Access Compliance Report

Public Rights-of-Way

(Curb Ramps)

Intersection ID: 10031975	Main Street: MONROE_RD	Cross Street: N/A	Location: NE
ADA ID: 0F85BF11E00C	Ramp Type: Perp	Initial Pass/Fail: Fail	Overall Compliance: No
Severity Score: 12.5			
Codes/Mitigation Info/Possible Solution		Field Measurements/Component Compliance

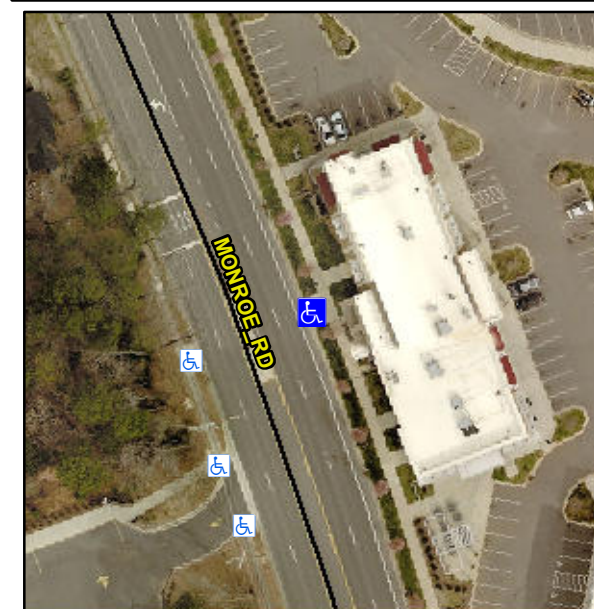
R304.2.2

Compliance	Description	Data	Compliance	Description	Data
N/A	Ramp Length (in)	96.0	No	Ramp Slope (%)	10.6
Yes	Ramp Width (in)	48.0	Yes	Ramp XSlope (%)	0.1
N/A	Flare Type LT	N/A	N/A	Flare Type RT	N/A
N/A	Flare Slope LT (%)	N/A	N/A	Flare Slope RT (%)	N/A
N/A	Flare Traversable LT?	N/A	N/A	Flare Traversable RT?	N/A
N/A	Landing Length (in)	N/A	N/A	DWS Provided?	N/A
N/A	Landing Width (in)	N/A	N/A	DWS Contrast?	N/A
N/A	Landing Slope (%)	N/A	N/A	DWS Length (in)	N/A
N/A	Landing X Slope (%)	N/A	N/A	DWS Full Width?	N/A
N/A	Landing Curb? (Y/N)	N/A	N/A	DWS Offset (in)	N/A
N/A	Shared Landing?	N/A			
N/A	Gutter Ponding?	N/A	N/A	Gutter Slope (%)	N/A
N/A	Gutter Lip Ht (in)	N/A	N/A	Gutter X Slope (%)	N/A
N/A	Painted X Walk1?	No	N/A	Painted X Walk2?	N/A
	X Walk 1 Direction	To SW		X Walk 2 Direction	N/A
N/A	X Walk 1 Width (in)	N/A	N/A	X Walk 2 Width (in)	N/A
	X Walk 1 Slope (%)	1.9		X Walk 2 Slope (%)	N/A
	X Walk 1 X Slope (%)	1.8		X Walk 2 X Slope (%)	N/A

Remove & Replace Entire Ramp.
